Planning Decisions Committee

6.30pm, Tuesday 6 September 2022

1. This report provides Council with an assessment of planning application PLN21/0788 which relates to land at No. 9 – 15 Brighton Street and land comprised in TP11938, Richmond. The report recommends a position of approval subject to conditions.

Ward: Melba
Proposal: The construction of a multi-storey building for office and food and drinks premises (no permit required for proposed uses) and a reduction in the car parking and visitor bicycle space requirements.
Existing use: Office
Applicant: LPC Nominee 30 Pty Ltd
Zoning / Overlays: Commercial 1 Zone (C1Z)
Design and Development Overlay – Schedule 5 (DDO5)
Design and Development Overlay – Schedule 27 (DDO27)
Development Contributions Plan Overlay (DCPO1)
Date of Application: 25 October 2021
Application Number: PLN21/0788

Figure 10: The proposed development compared to heights of nearby approvals to the west. The red outline shows the extent recommended for deletion.

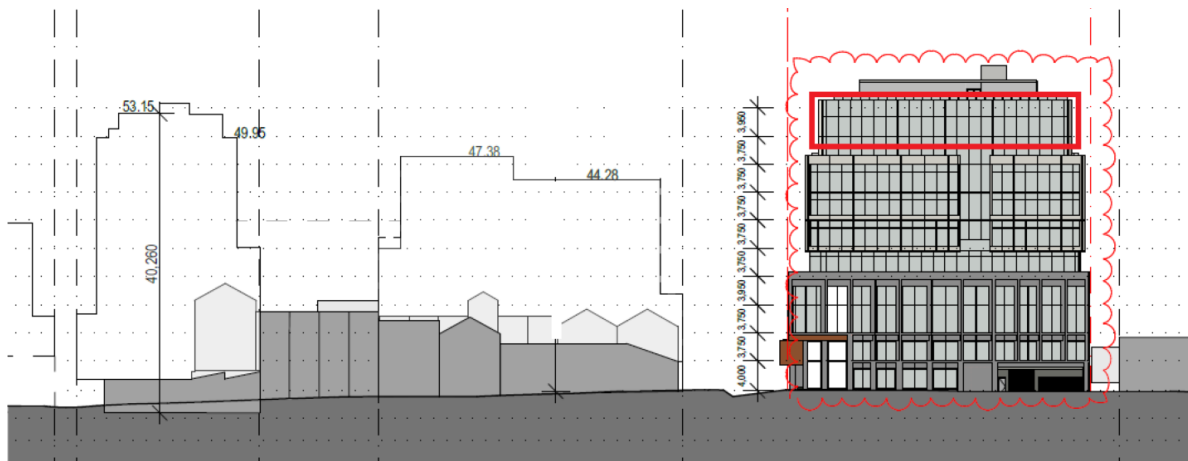
144. The reduced height also ensures that the development would better accord with the approved developments nearby at 1 Little Lensey Street and 2-8 Brighton Street as shown below at figure 10.

145. Furthermore, the reduced height provides an improved relationship between the podium form (four storeys) and the upper level form (total of six storeys when accounting for the deletion of level 09). The deletion of level 09 will also not affect the well-resolved façade recesses below at levels 05 – 07, ensuring that design excellence will be maintained with the proposed condition. The Planning Officer has generated an image to approximately demonstrate the appearance of the development with the deletion of level 09, as shown at figure 11 below (note that the elevations, when zoomed out as per the image below, do not show the red colour of the brick podium levels).

Figure 11: An approximate depiction of the proposal with level 09 deleted, prepared by the Planning Officer.

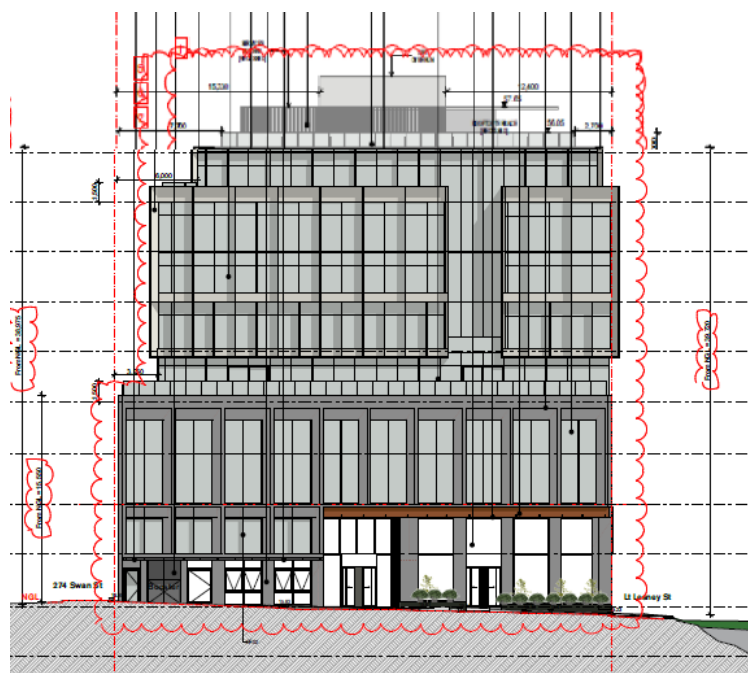
146. DDO27 states that a permit should only be granted to exceed the preferred maximum building height where all the following requirements are met to Council's satisfaction:

Figure 15: The sketch design prepared by Council's Urban Design Unit

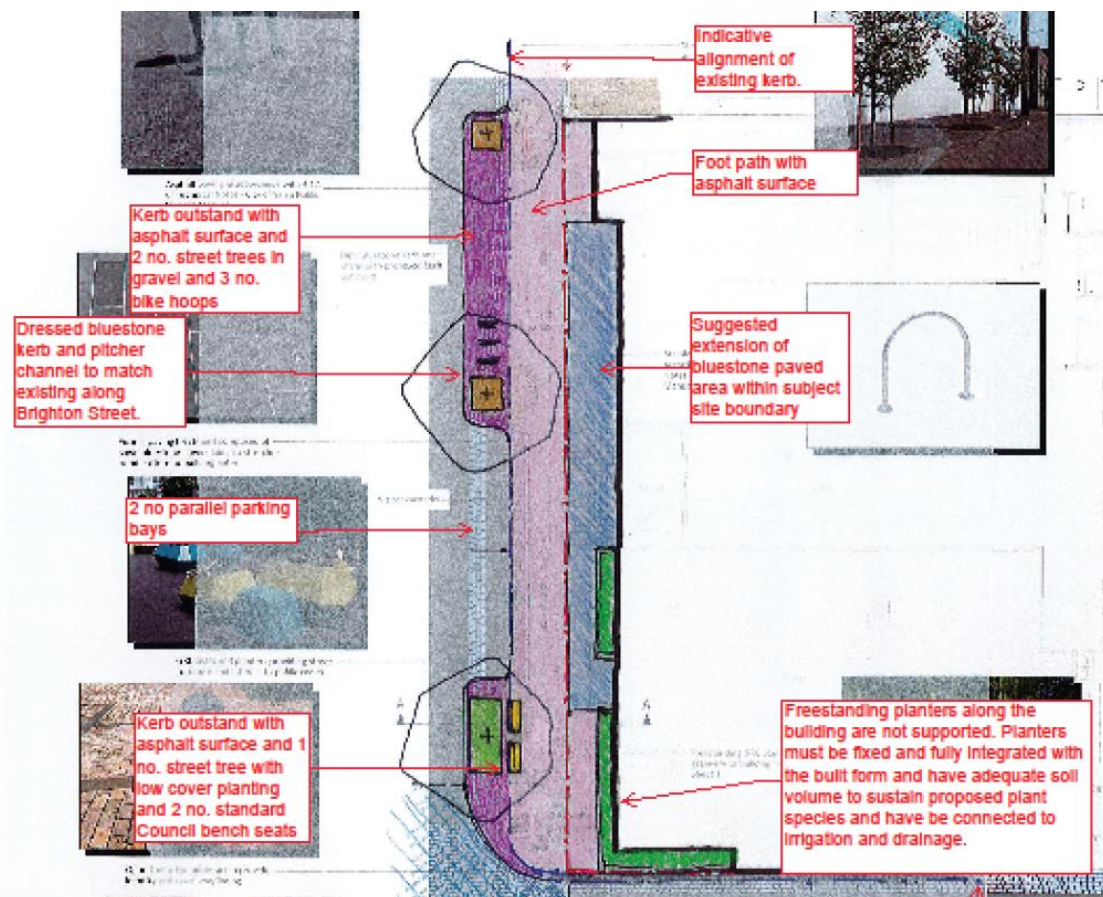
168. The sketch design provided by Council's Urban Design Unit is considered to be significantly more resolved and amenable for pedestrians. It also will enable more efficient maintenance of the kerb outstand into the future. For these reasons, a condition will require the public realm plan to be updated to be generally in accordance with the sketch design. The use of 'generally in accordance' allows for minor design changes to be made if necessary. In addition to the changes shown by the sketch design, Council's Urban Design Unit called for the following additional changes to be made to the public realm plan:

Figure 17: Extent of 10am equinox shadowing on the western footpath of Brighton Street

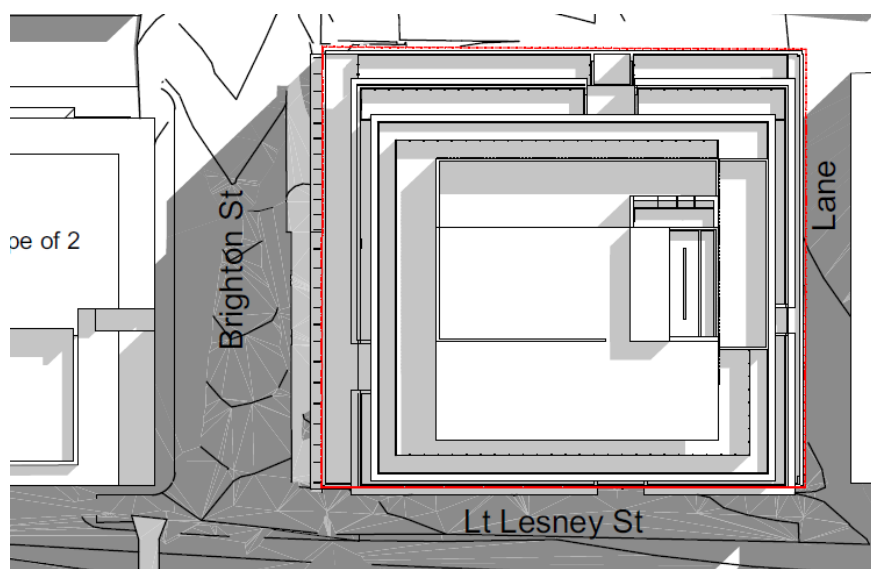
194. The design objectives of the DDO27 call for the protection of solar access to the public realm. The overshadowing requirements of the DDO27 include specific requirements to protect a number of footpaths in the area (between the equinox hours of 10 – 2pm as relevant), but Brighton Street is not included in these. Therefore, Brighton Street is not specifically protected by the DDO27 in terms of footpath solar access.
195. The submitted shadow diagrams show that the proposed development will result in substantial shadowing to the western footpath of Brighton Street at 10am on the equinox (as shown at figure 17 below). From 11am to 3pm, the proposed development will not result in any new equinox shadowing to the western footpath of Church Street.

196. The proposed western footpath shadowing at 10am is supported in this case for the following reasons:
 - (a) Brighton Street is relatively narrow (15m wide), making the mitigation of shadows difficult;

Figure 19: The kerb outstand arrangement recommended by Council's Urban Design Unit has space for additional visitor bicycle spaces (shown in yellow outline)

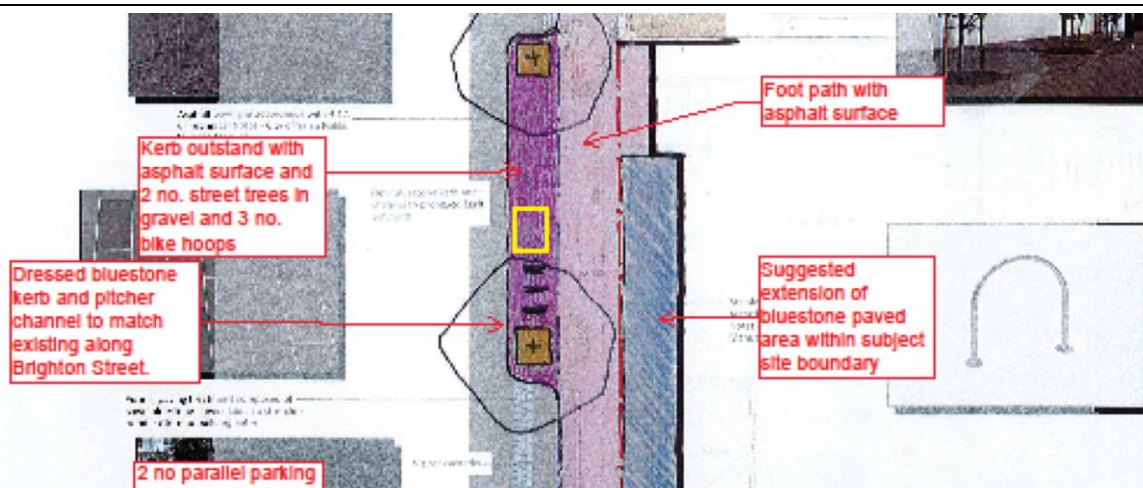
This sketch shows six visitor spaces (three hoops), but it also show an area of asphalt that is unused and could be utilised for the additional spaces (see yellow outline at figure 19 below). This would further encourage visitors to arrive to the site via bicycle and would not create any pinch points in the public realm given the generous size of the kerb outstand recommended by the Urban Design Unit. In light of this, a condition will require (in addition to the sketch plan by Council's Urban Design Unit), the provision of an additional four visitor bicycle spaces (two racks) to the north of the visitor bicycle spaces.

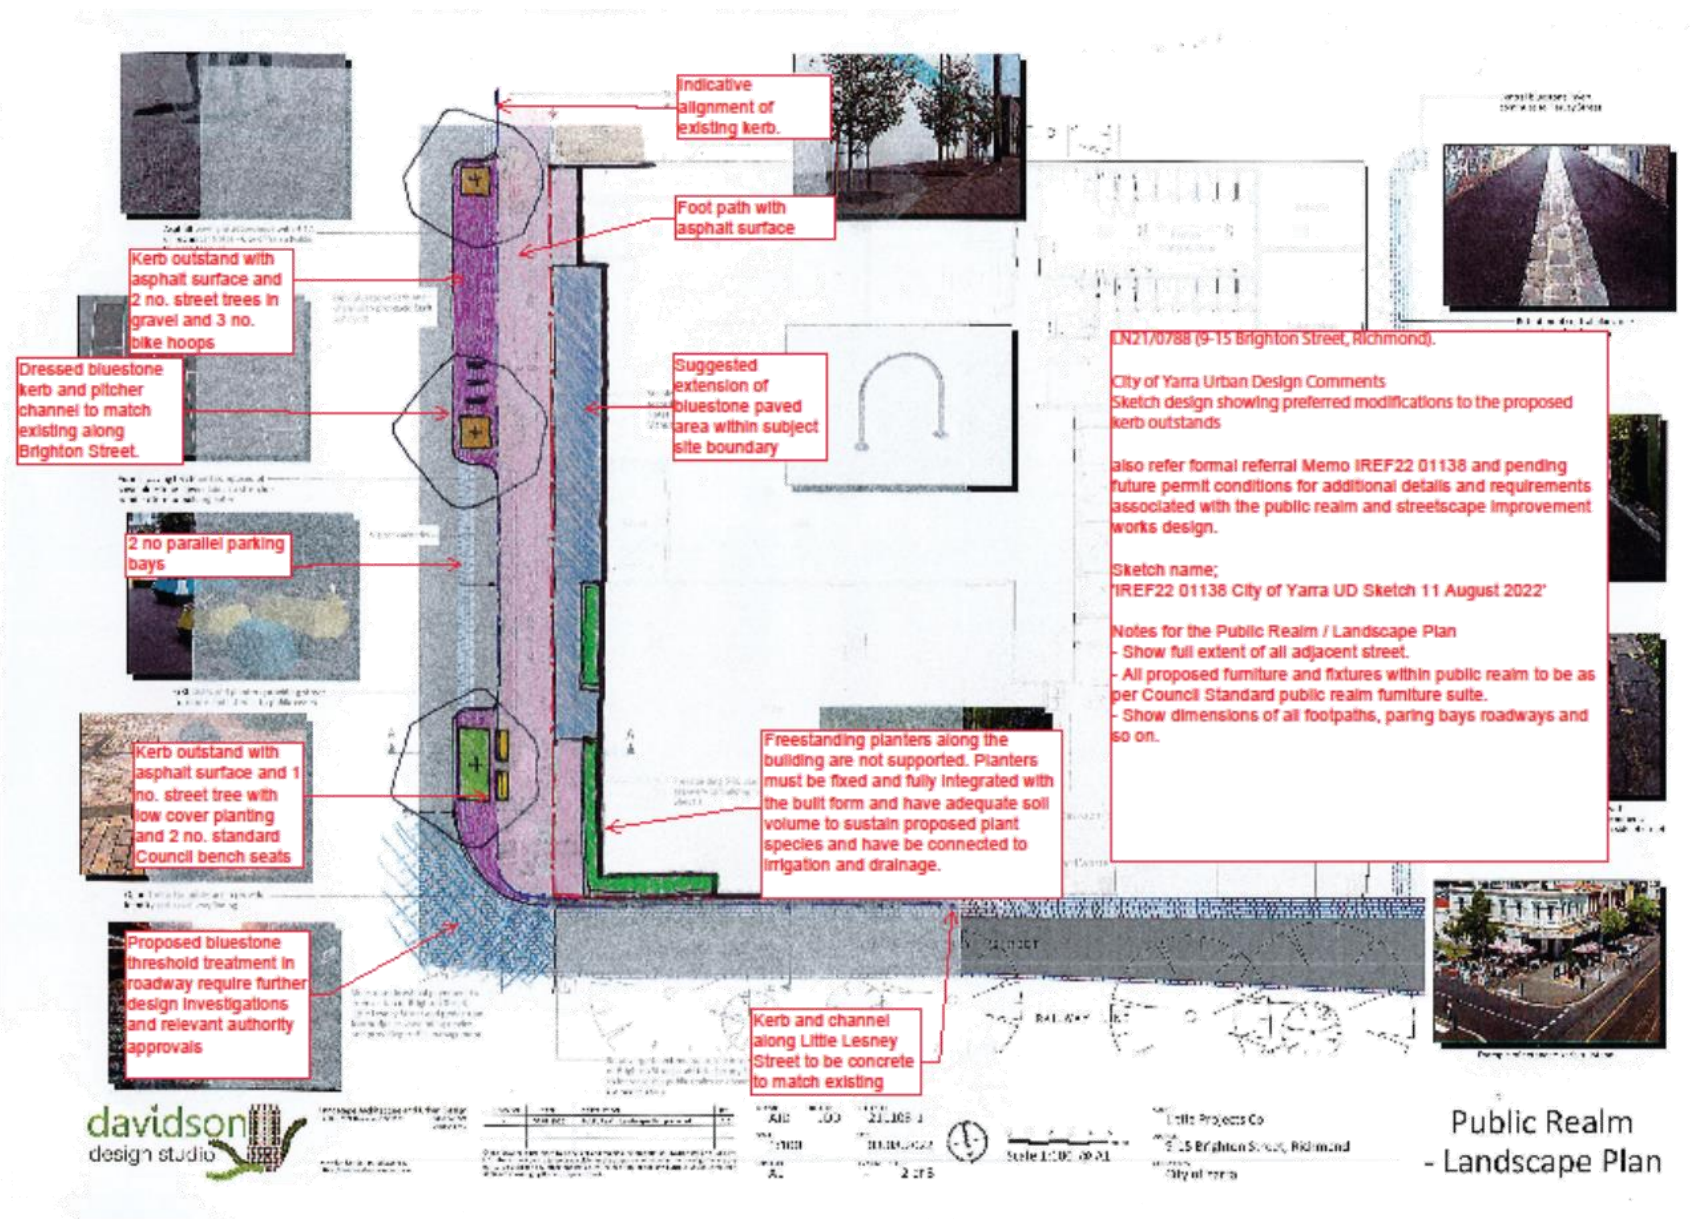
It is request that the proposed streetscape and public realm design is modified as shown on the attached sketch '*IREF22 01138 City of Yarra UD Sketch 11 August 2022*' including but not limited to also addressing the items listed below:

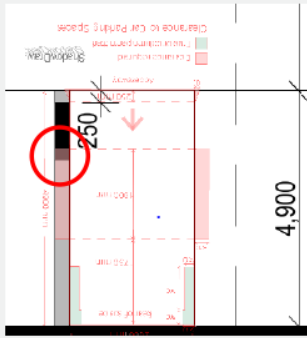
Ramp Grade for the first 5.0 metres inside the Property	The ramp grade for the first 5.0 metres inside the property is flat to satisfy <i>Design standard 3 – Gradients</i> .
Ramp Grades and Changes of Grade	The ramp grades and changes of grade satisfy <i>Table 3 Ramp Gradients</i> of Clause 52.06-9.
Other Items	
Loading Arrangements	The size of the internal loading bay has not been dimensioned on the drawings.
Vehicle Crossing Ground Clearance	A vehicle crossing ground clearance check is to be undertaken for each new vehicle crossing by the applicant's designer to confirm that a B99 design vehicle can enter and exit the property without scraping out (Please see under ' <i>Engineering Advice for Design Items to be Addressed by the Applicant</i> ' section).
Vehicle Turning Movements – Loading Bay	The swept path diagrams for a 6.4 metre long Small Rigid Vehicle demonstrates adequate turning movements into and out of the loading bay off Little Lesney Street.

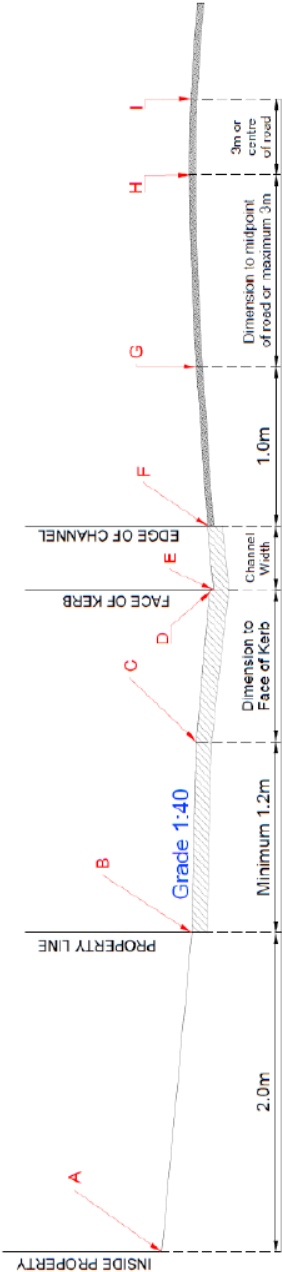
| D. Bullnose (max height 60mm) – must be clearly labelled | H., I. Road levels |

- o Please note the cross section must be fully dimensioned. As shown in the sketch below.
- o Please show both the existing and proposed surface.
- o The maximum allowable cross-fall between points B and C is 1:40 (2.5%).
- o A bullnose (max 60mm) is permitted at point D, however not compulsory.
- o The levels shown must be exact reduced levels, to three decimal points. Interpolation of levels is not acceptable.
- o The designer must demonstrate that an 85th or 99th percentile vehicle profile can traverse the design cross section as per the Australian/New Zealand Standard ground clearance template (AS/NZS 2890.1:2004).
- o Significant level changes to the existing footpath level B to C will require additional level design either side of the proposed crossing.
- o Please include any additional levels or changes in grade that are not shown in the diagram.
